Tennessee Valley Authority, 1101 Market Street, Chattanooga, Tennessee 37402

CNL-15-127

Watts Bar Nuclear Plant, Unit 2  
Construction Permit No. CPPR-92  
NRC Docket No. 50-391

Subject: **Revised FSAR Section 6.2.1 Containment Functional Design**

**Figure 4.4.3-1 Containment Pressure Transient**

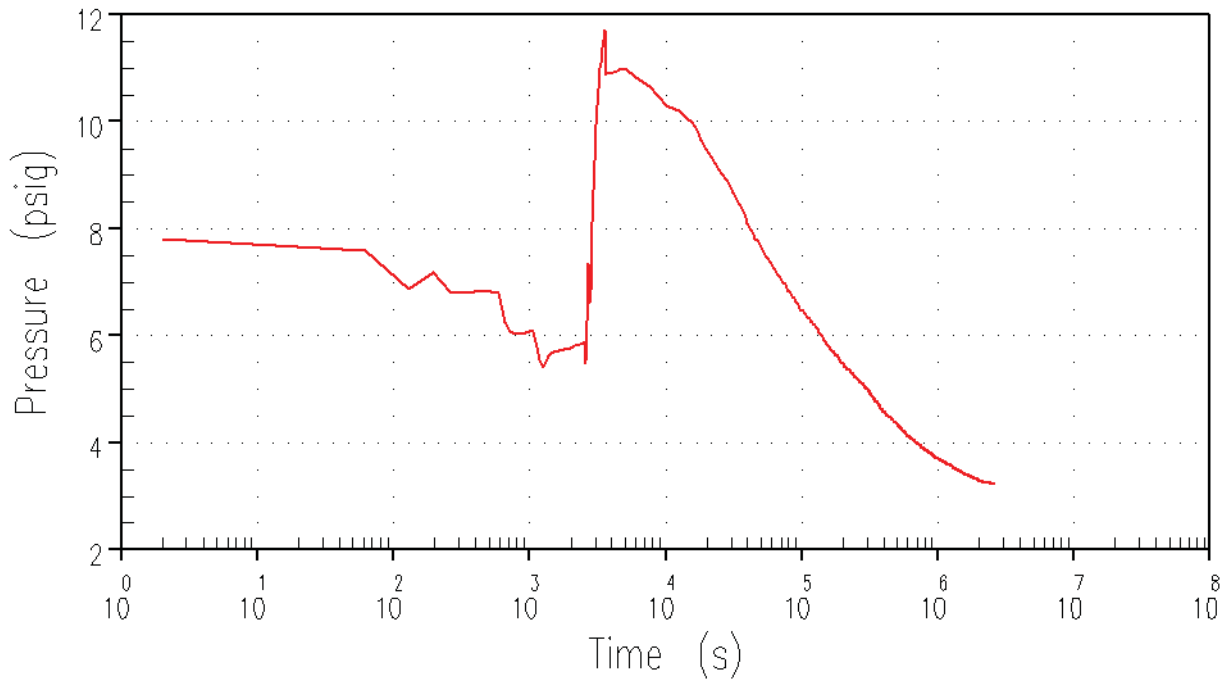
The results of the analysis show that the maximum calculated containment pressure is 11.73 psig, for the DEPSG minimum safeguards break case, assuming an ice bed mass of  $2.585 \times 10^6$  lbm. This pressure is less than the design pressure of 15.0 psig as well as the administrative limit of 13.5 psig and, therefore, shows the acceptability for Unit 2. The pressure peak occurs at approximately 3,600 seconds (approximately 60 minutes), with ice bed melt-out at approximately 2,959 seconds (approximately 49+ minutes). It is noted that the apparent containment pressure margin between 11.73 psig and the design pressure cannot be used to further reduce the ice mass. The ice bed mass is limited by the spray switchover time of 2,718.7 seconds (approximately 45 minutes) and the margin between spray switchover and ice bed melt-out of at least 150 seconds (2.5 minutes).

Figure 6.2.1-1 Containment Pressure Versus Time

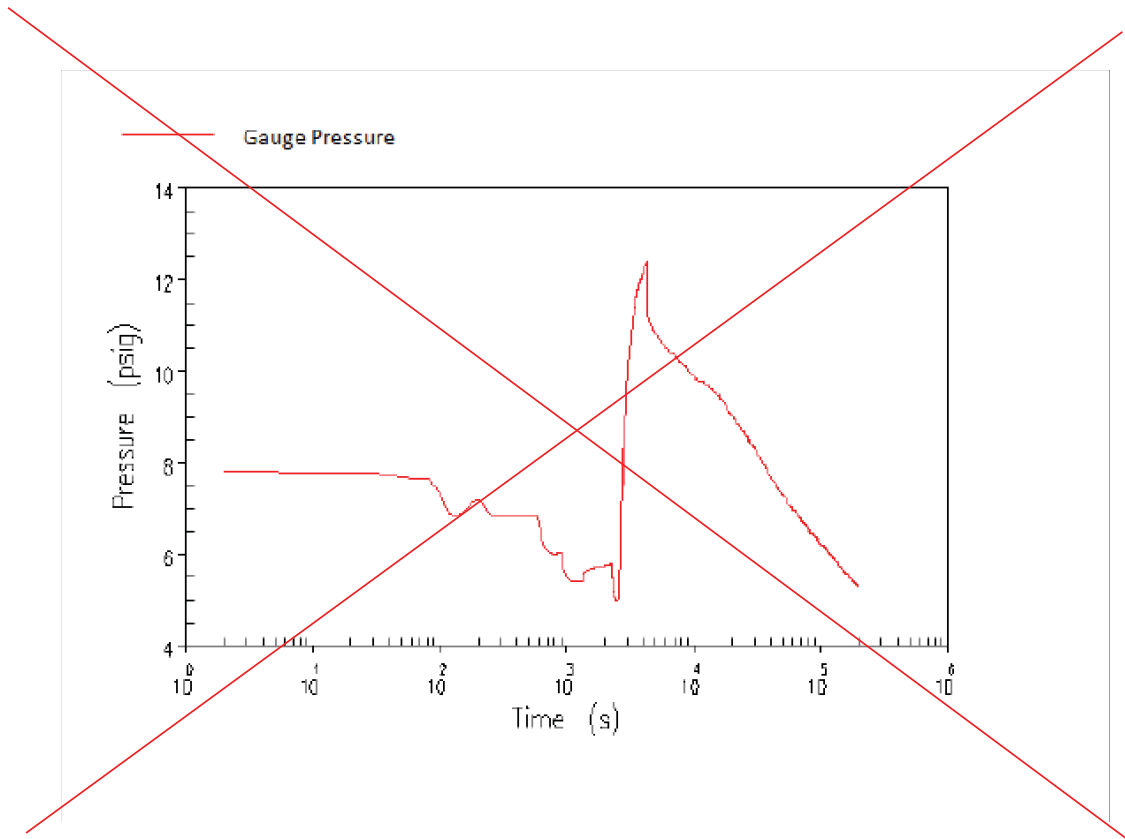
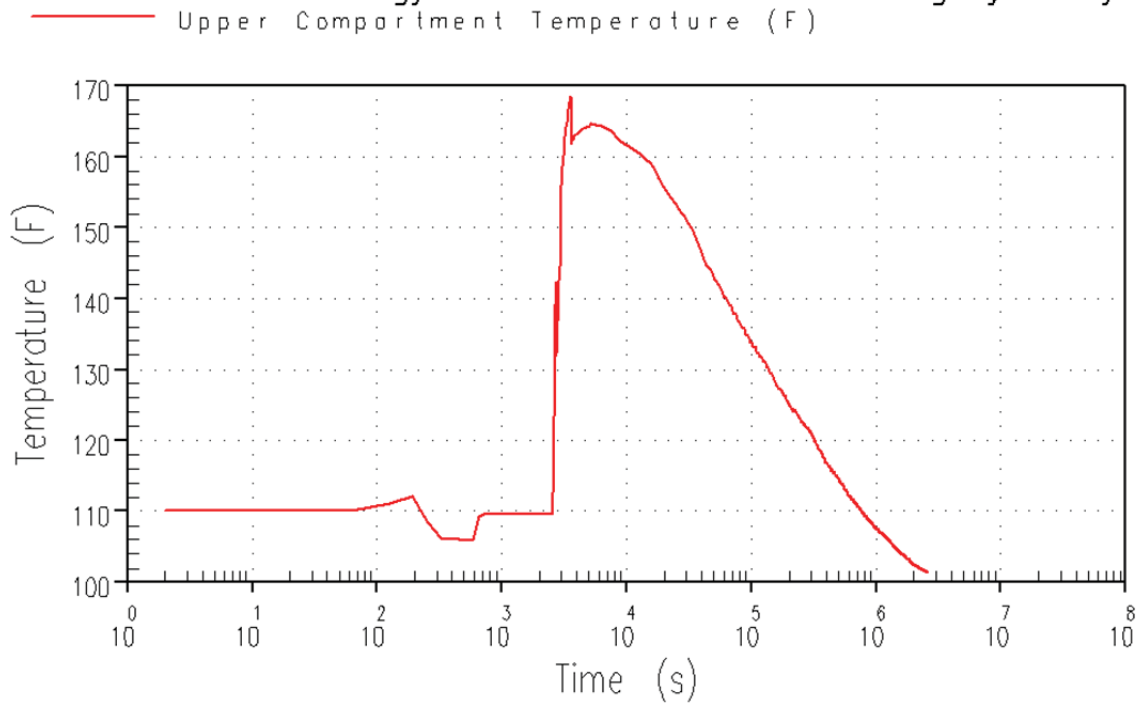
As can be seen from Figure 6.2.1-1 the maximum calculated Containment pressure is ~~12.40 psig~~, occurring at approximately ~~4346 seconds~~.

Insert K
